DURACELL INC.
NORTH TARRYTOWN, NEW YORK

HAZARDOUS WASTE
STORAGE FACILITY
CLOSURE PLAN
ADDENDUM REPORT NO. 1

PROJECT #425-1
REVISED APRIL 1986

EDER ASSOCIATES
CONSULTING ENGINEERS, P.C.
85 Forest Avenue
Locust Valley, New York

FIGURE 1

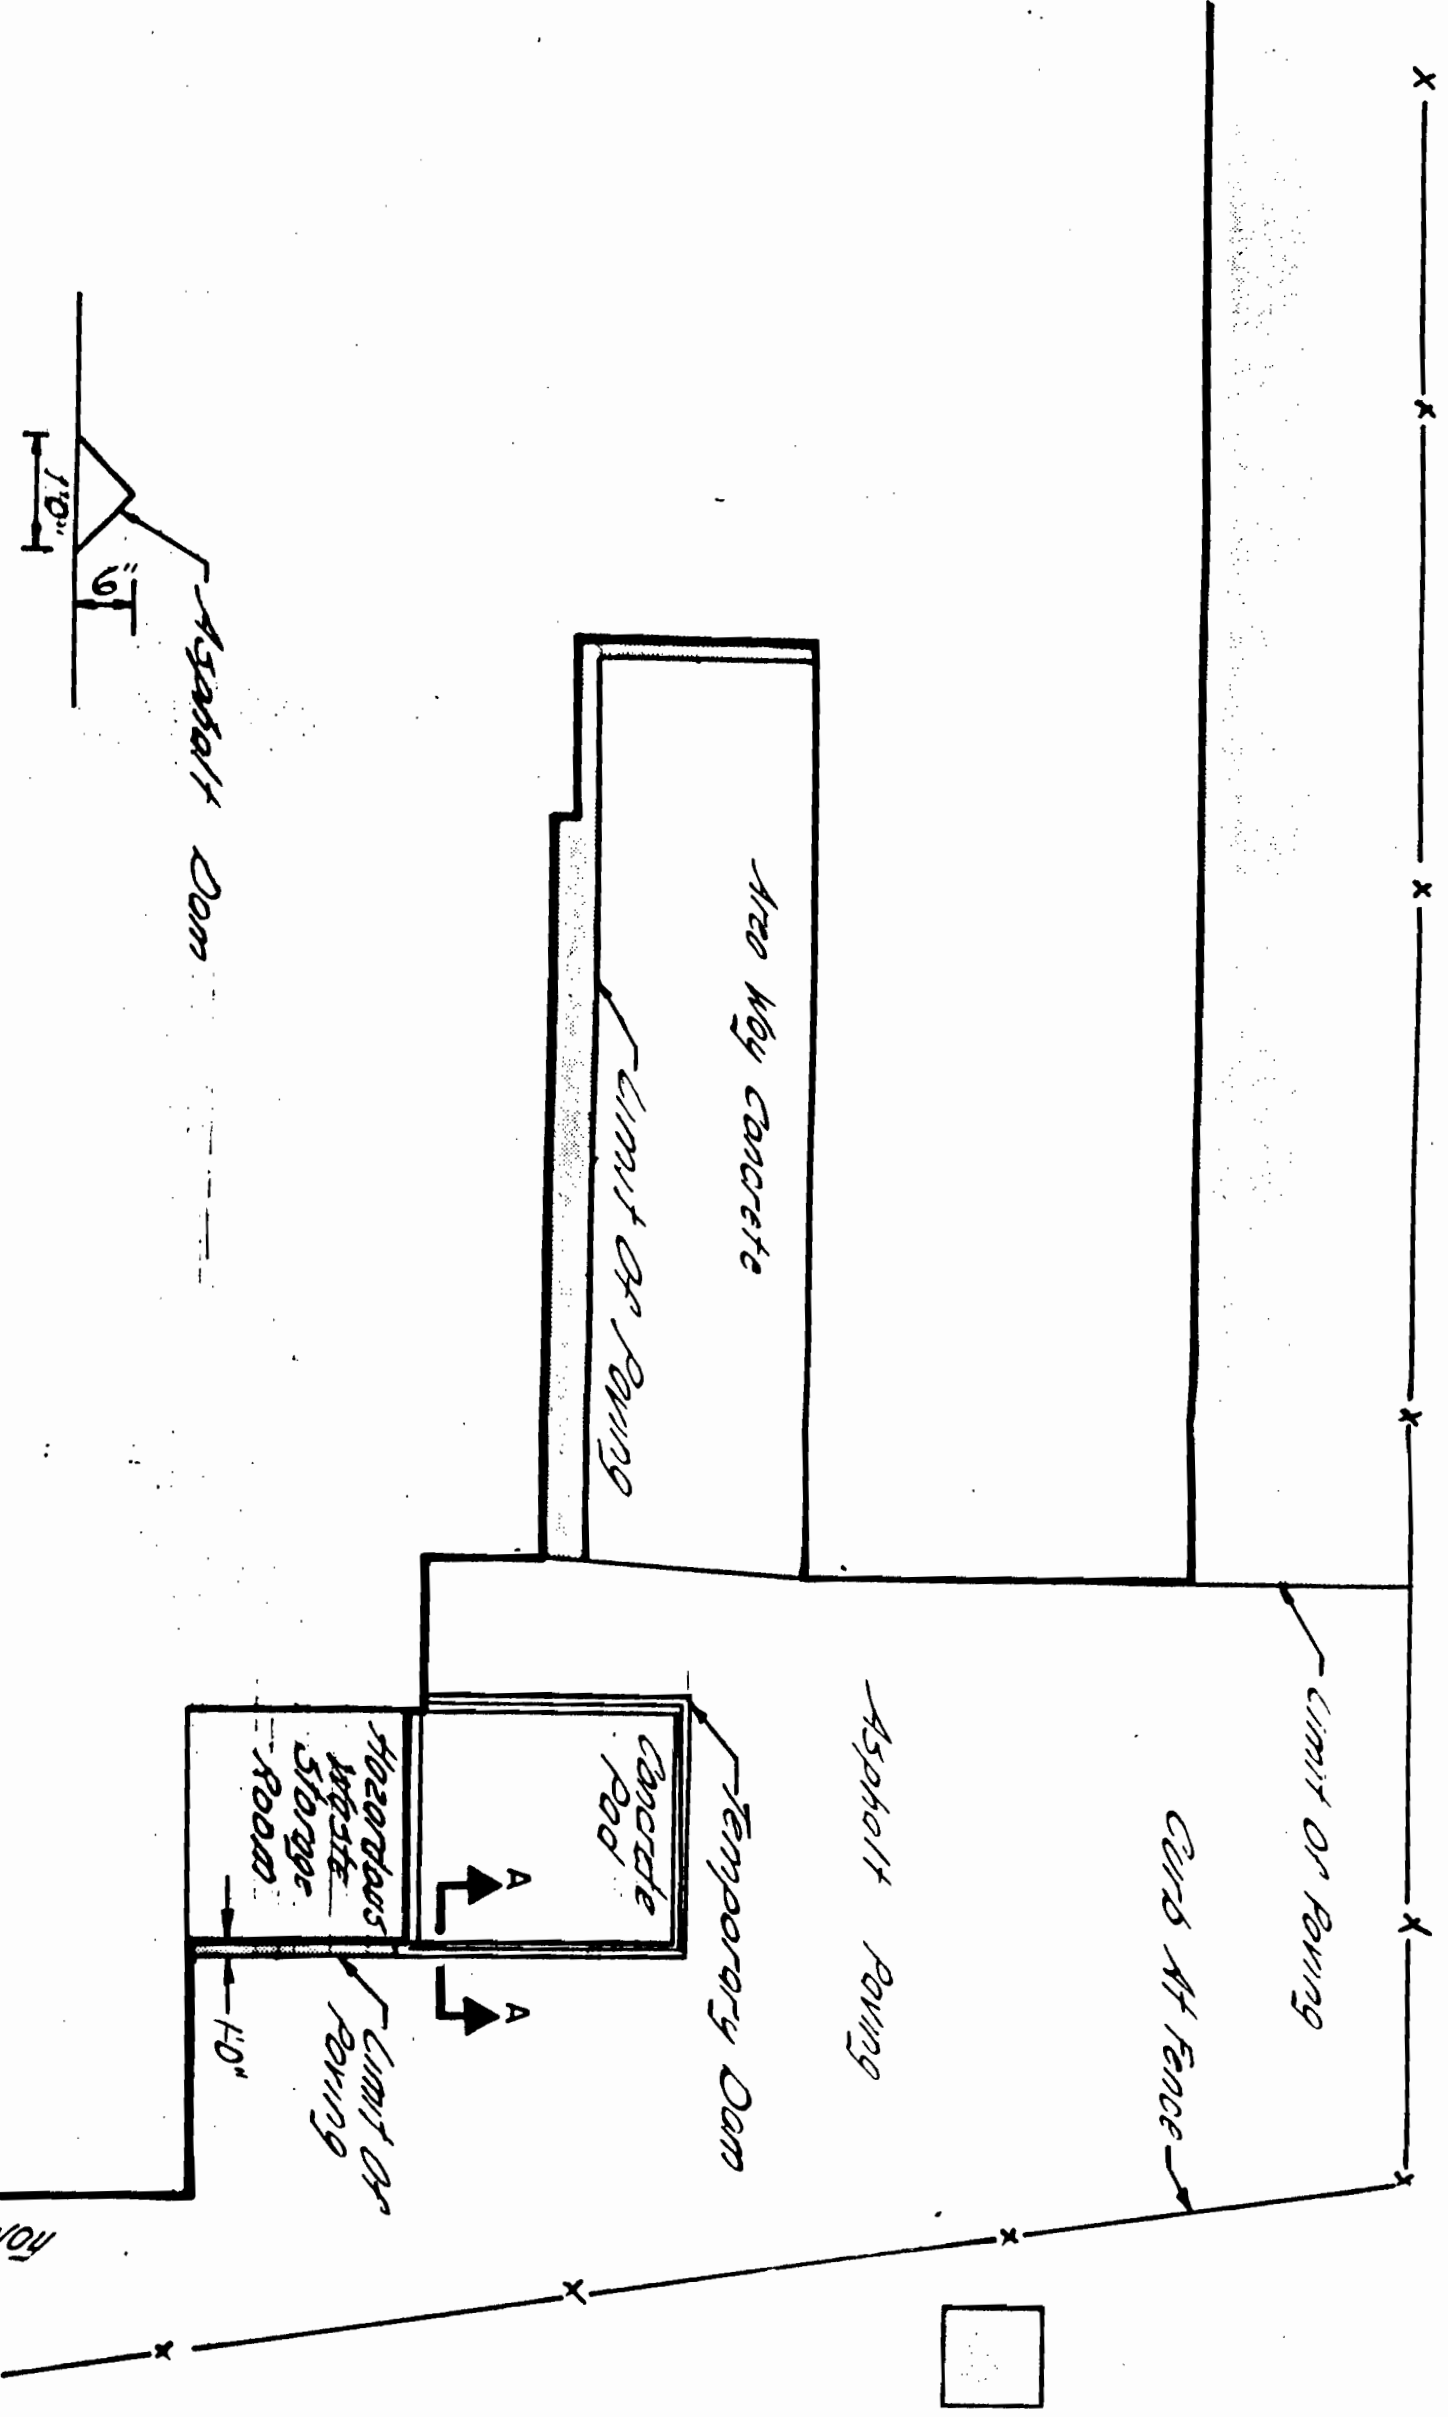
- 9) "Page 11 of the report indicates that there is an "impervious surface around the storage area." But on Page 4, it is indicated that the backyard is "generally paved." These two statements should be consistent. Please clarify."

- 11a) "Indicate in a drawing the dam to be built around the building as a containment for wash waters and rinse waters. Describe the dam height and how will the wastewater be collected in the dam; dam capacity; estimated volume of wastewater; dam material; dam removal after job is completed and dam disposal.
- b) Page 9 indicates that liquids from building surface cleaning will be pumped into bulk tanker trucks. This does not seem to be consistent with the proposal to contain wash waters and rinse waters behind dam."

Figure 1 shows a plot plan of the southeast yard area with the Hazardous Waste Storage Facility consisting of two storage rooms and concrete pad. The temporary dam will be constructed to collect runoff from washing activities related to decontamination of the Hazardous Waste Storage Facility (refer to Item 11). Most of the yard area, including the driveway along the south property line, is either paved with asphalt or concrete. An asphalt curb is located along the south and east property line. The limit of paving is indicated at the southeast corner of the plant. Two thin strips of non-paved areas are located along the west side of the areaway and adjacent to the south wall of the storage rooms.

The soil remediation program, described in the On-Site Report, includes removal of soil from much of the southeast yard area. This includes most of the non-paved area in the areaway and adjacent to the storage rooms.

The proposed dam around the Hazardous Waste Storage Facility is shown in Figure 1. The area enclosed by the dam is:

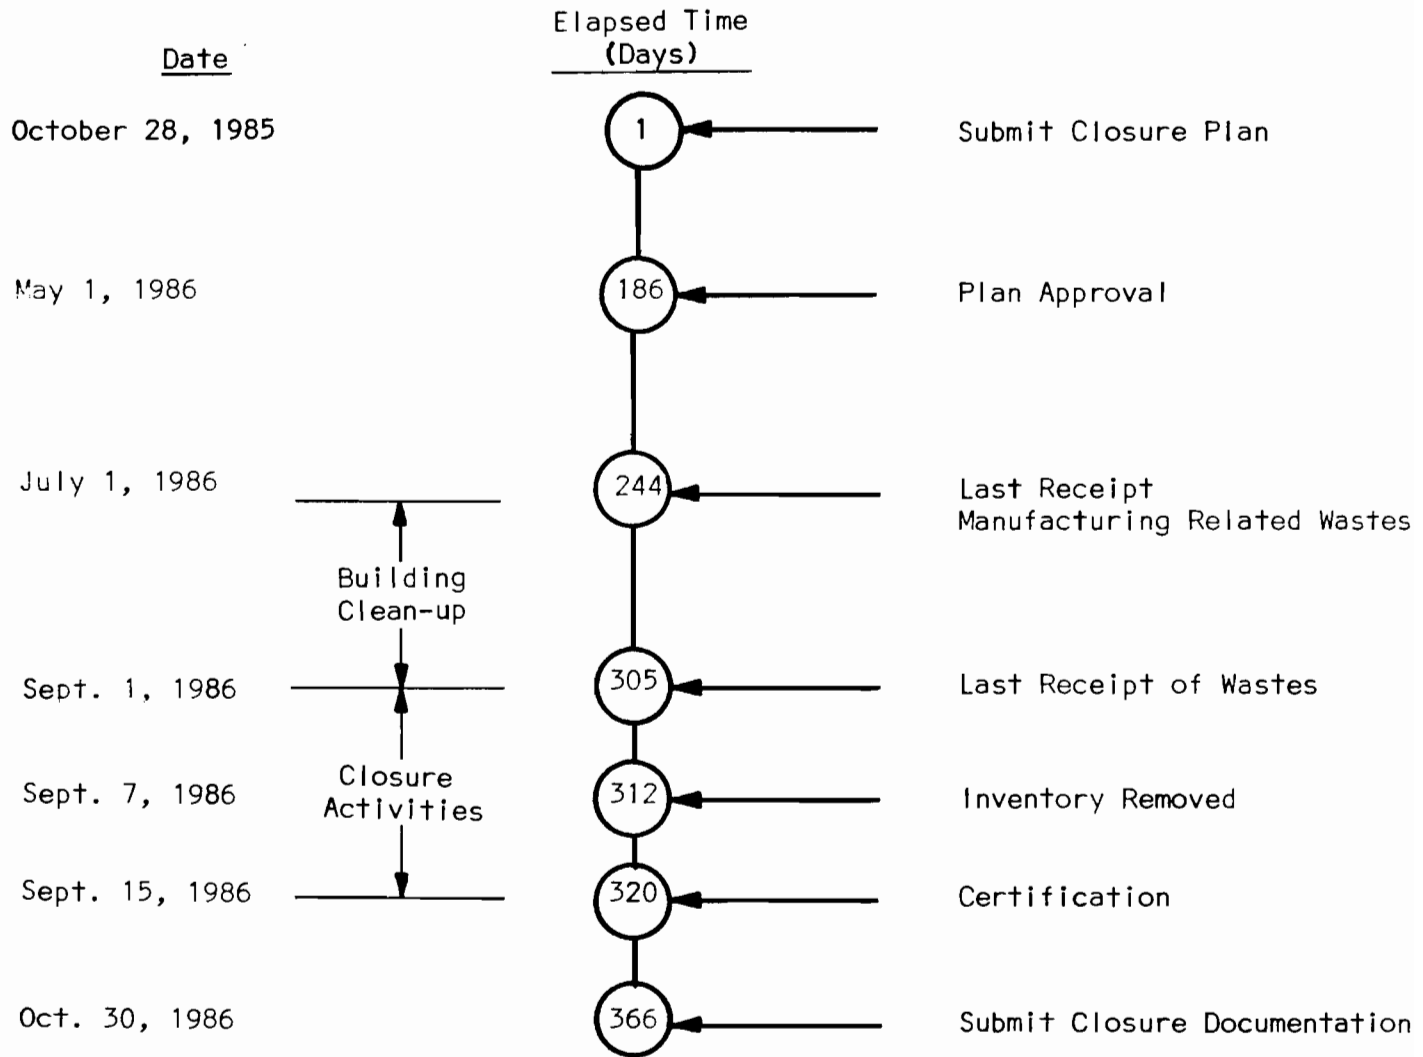
14) Revised Closure Schedule

The revised closure schedule is presented in Figure 2. The schedule is dependent upon the DEC approval of the remediation plans including building clean-up which must precede closure of the Hazardous Waste Management Facility.
